**RFI 098
Pebble Project EIS**

Title/Subject:	TSF Options, Mine Area
Requestor:	AECOM
Date Transmitted:	10/16/2018
Recipient:	Pebble Limited Partnership (PLP)
Response Requested by:	10/22/2018
Rationale:	The PLP response for RFI 069 presented 26 potential TSF locations that were considered near the mine area. Details on feasibility and environmental considerations for these locations are necessary for alternatives screening purposes and for the USACE to evaluate the Least Environmentally Damaging Practicable Alternative (LEPDA).
Describe the Information Requested and Level of Detail:	<p>Please provide an evaluation of each mine area TSF location that was considered and explain why the NFK West and NFK East locations were ultimately selected. Include:</p> <ul style="list-style-type: none"> • Feasibility (technology, economics, logistics, common sense) • Availability (both now and ten years ago during project planning) • Environmental impacts (wetlands/Waters of the US, miles of streams, habitat, fill, dam safety, etc.)

The question presented in RFI 098 on TSF options in the mine area is addressed below:

TSF OPTION 5

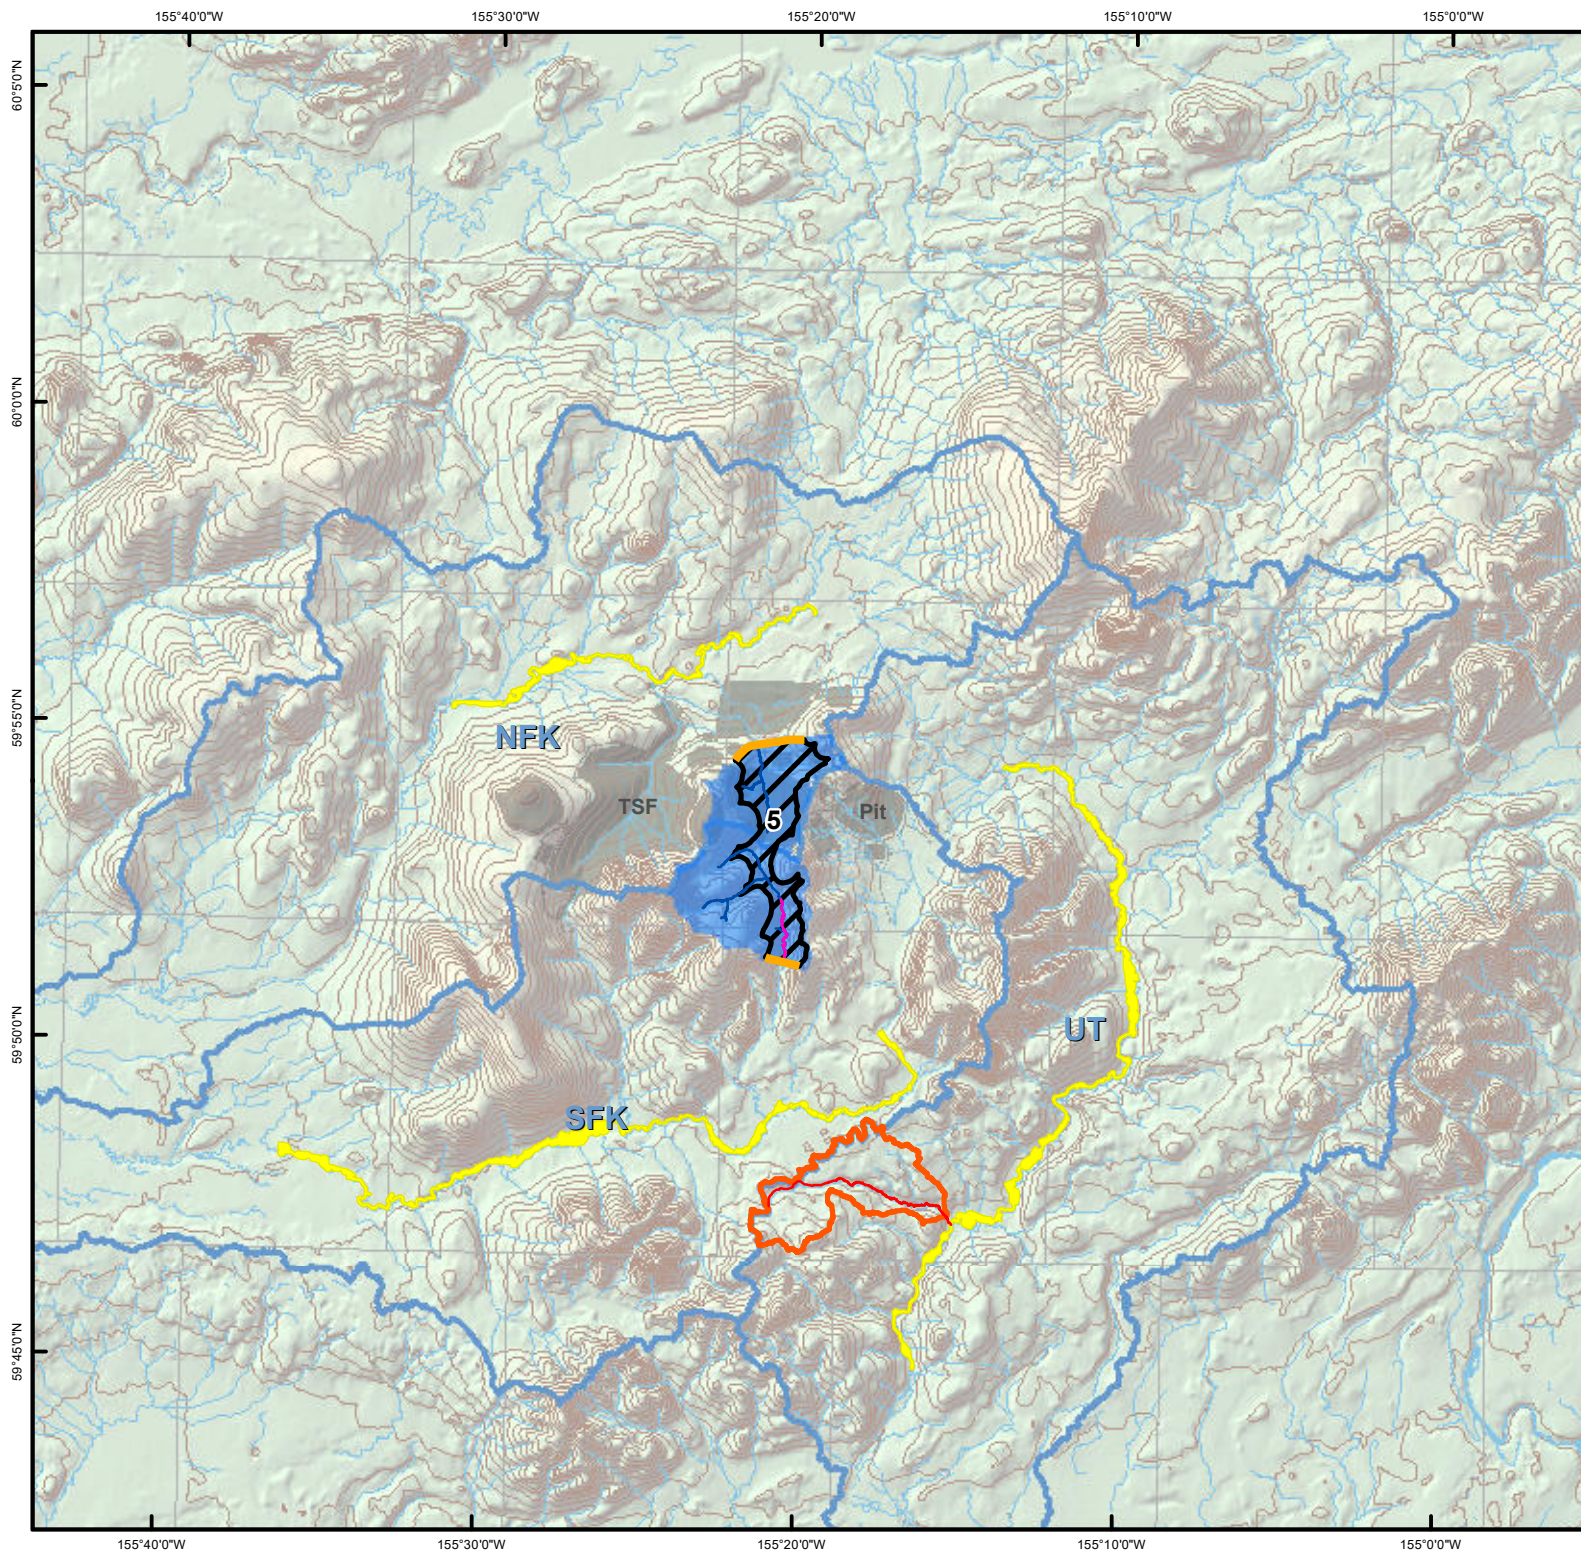
Option 5

- Does not have sufficient capacity to store all the tailings for the proposed project.
- A significant portion of the footprint is utilized for the storage of pyritic tailings in the proposed project.

TSF OPTION 6

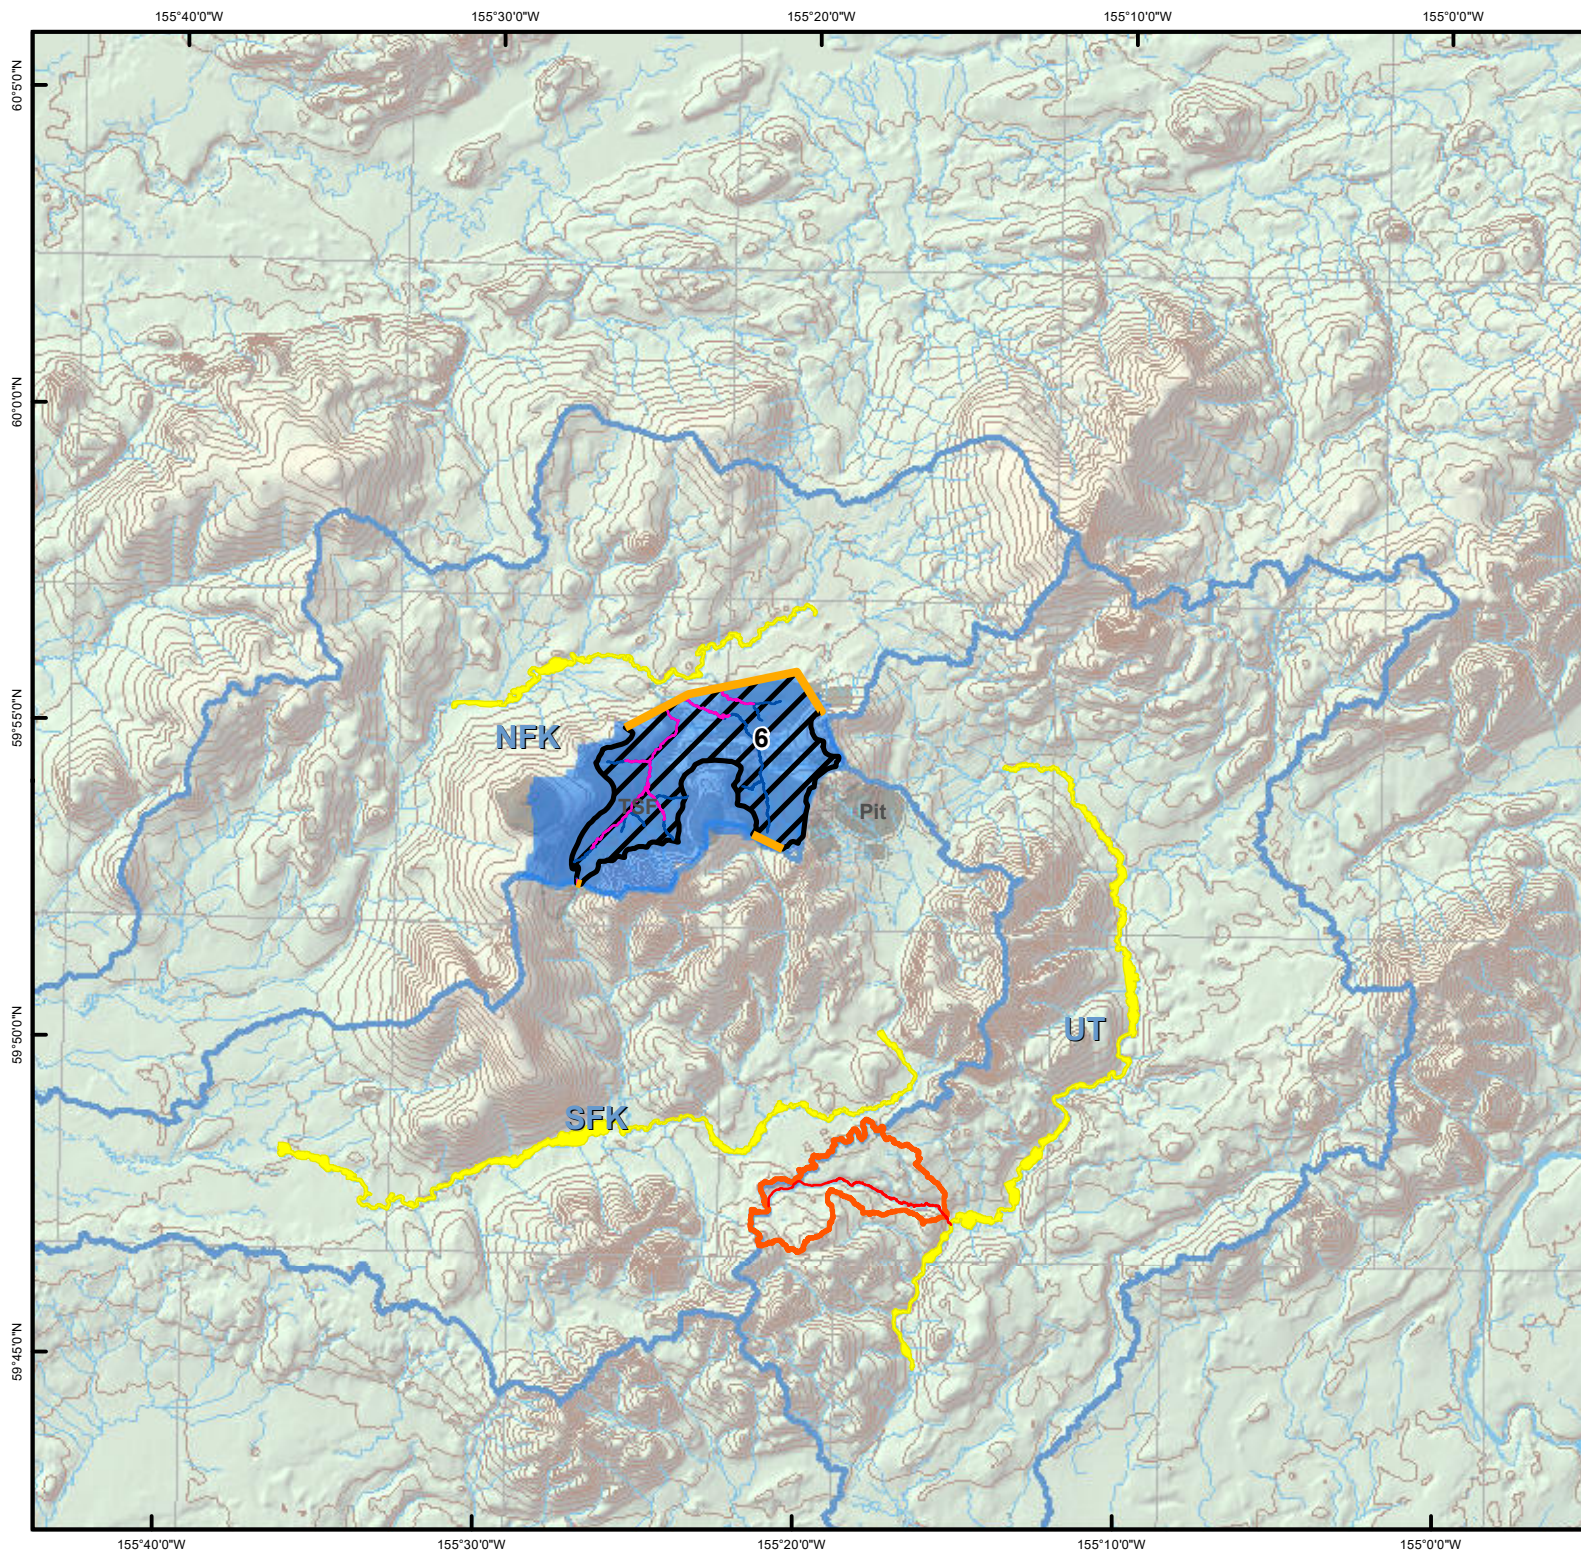
Option 6

- Is coincident with much of the proposed project but has significantly larger impacts in all categories related to the footprint and stream impacts.

TSF OPTION 7

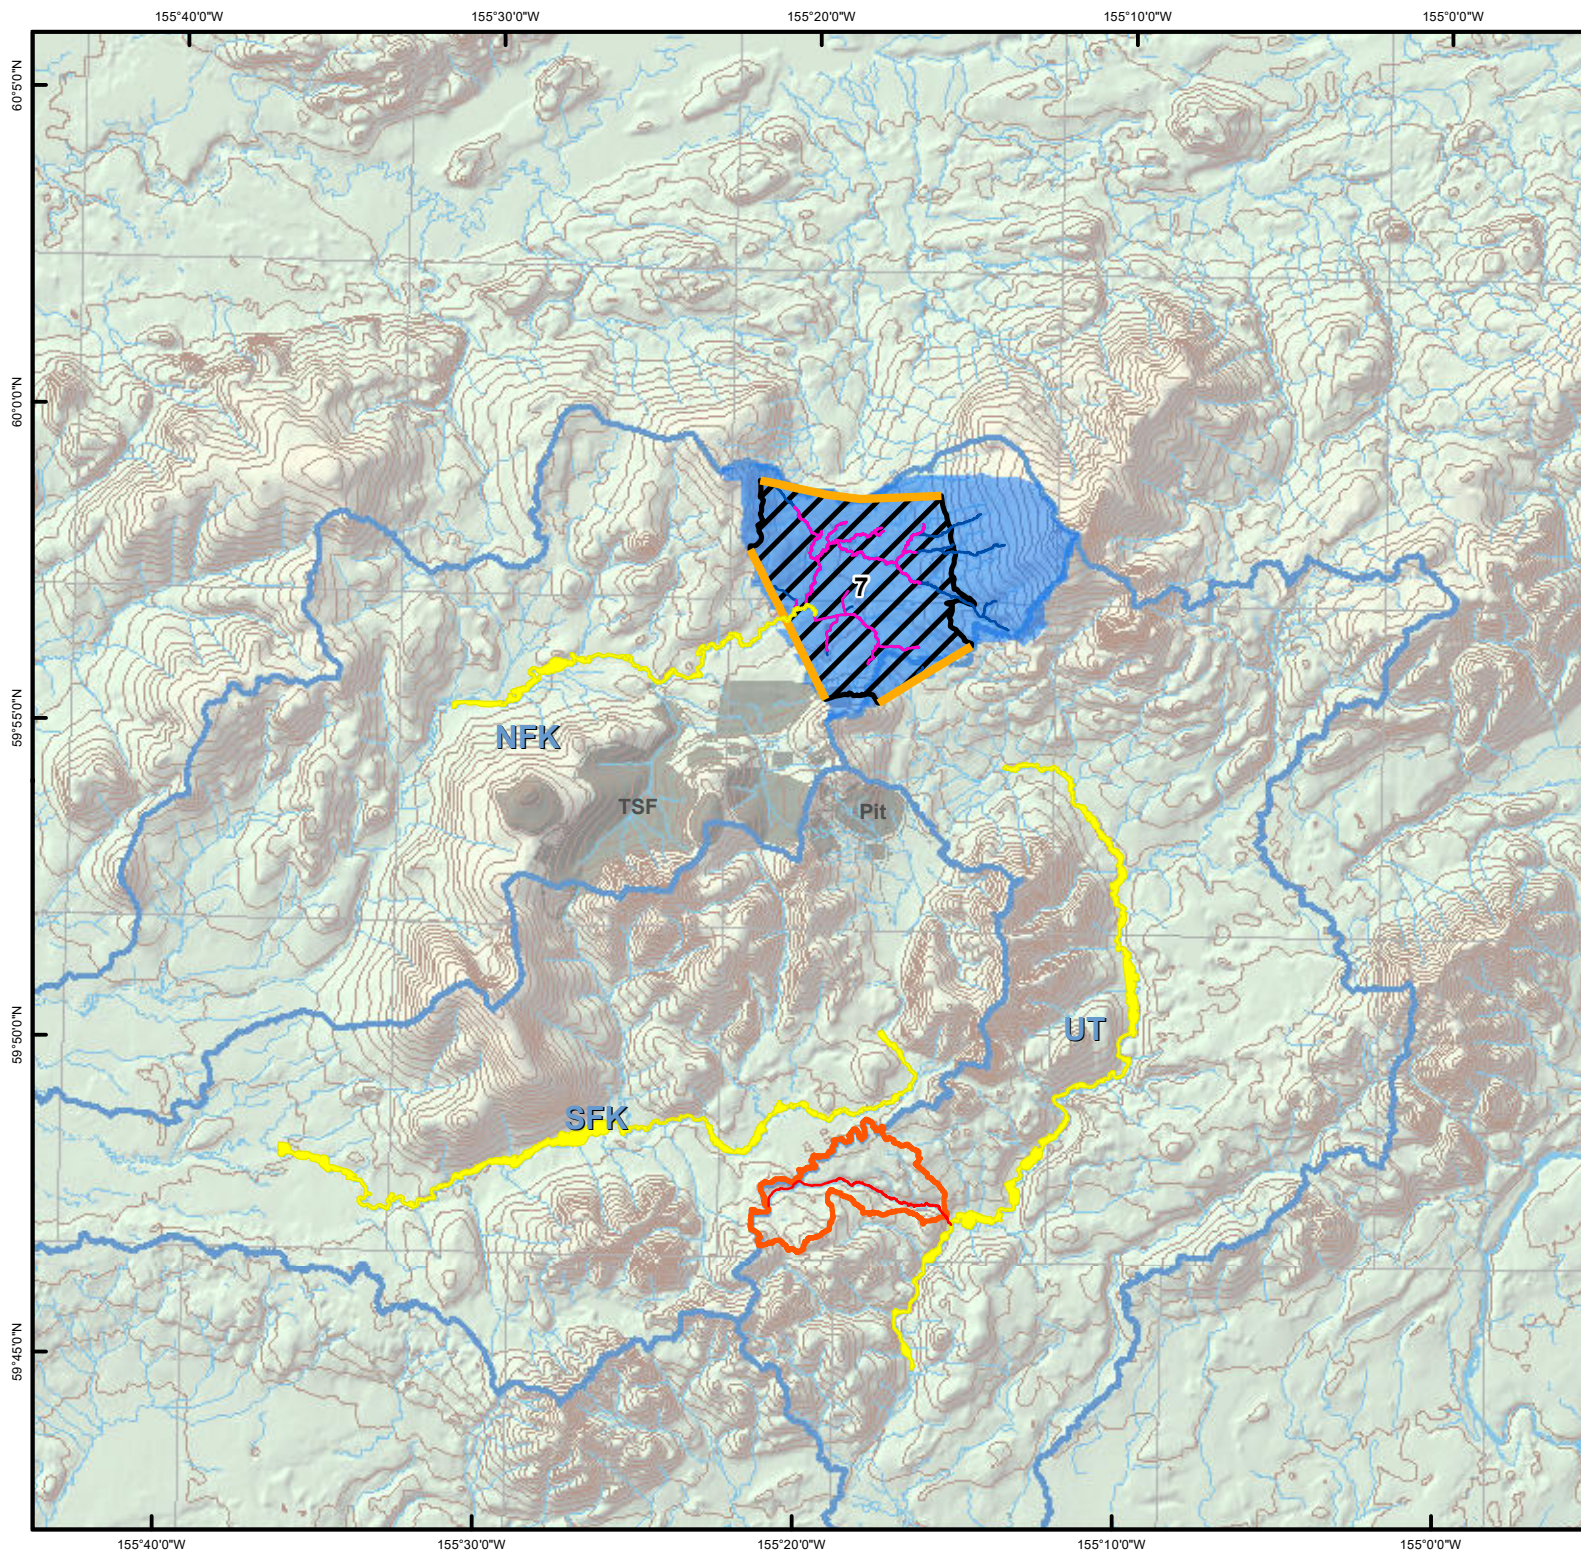
Option 7

- Has significantly larger impacts in all categories related to the footprint and stream impacts.
- The footprint encroaches on MCO393.

TSF OPTION 8

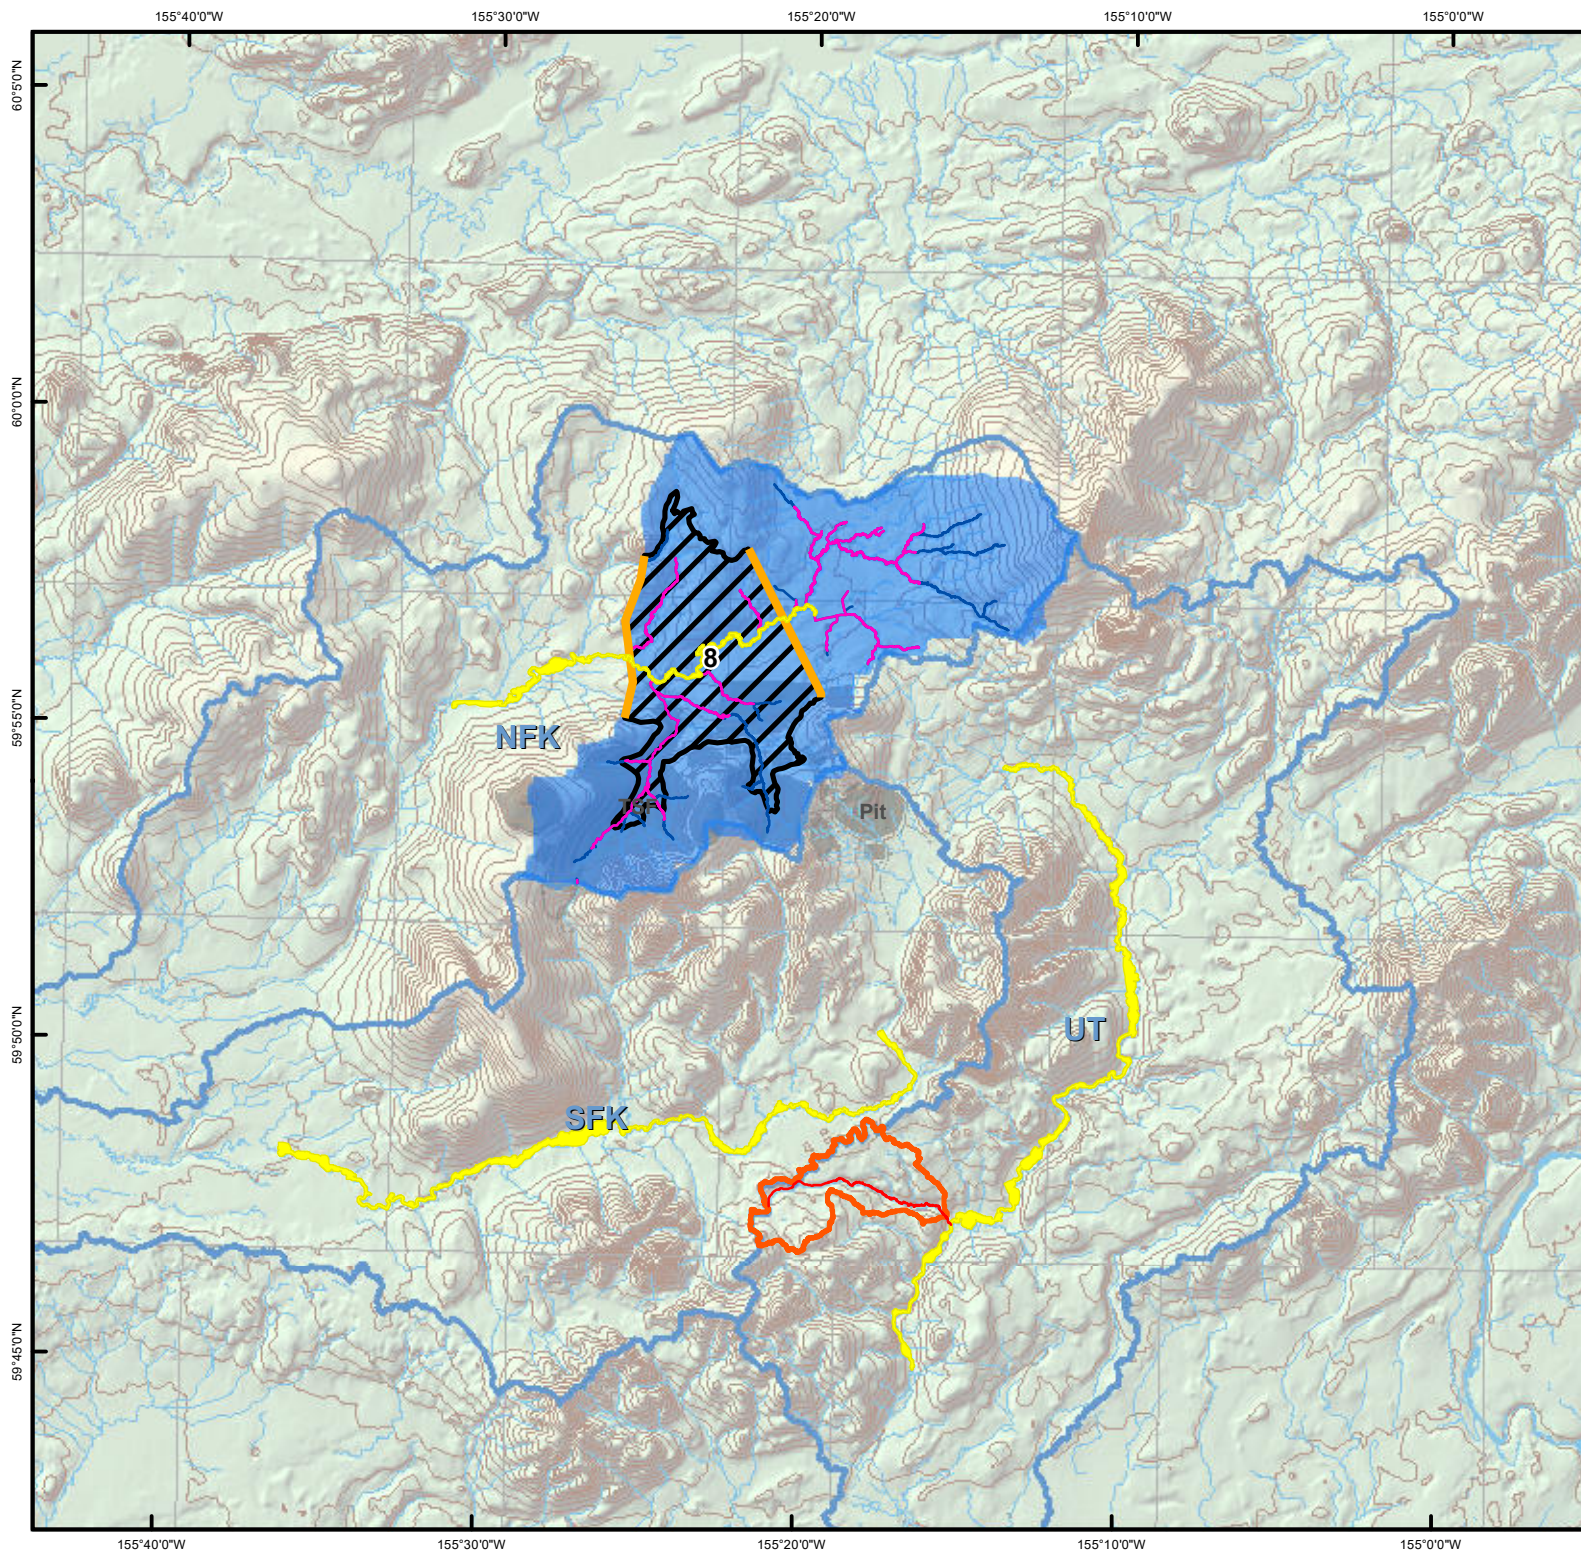
Option 8

- Fills slightly less mapped wetlands but has a much larger overall footprint and fills nearly three times as many stream miles.
- The impacted drainage basin and impacts to fish-bearing and anadromous streams are significantly higher.
- The footprint has extensive overlap with MCO393.
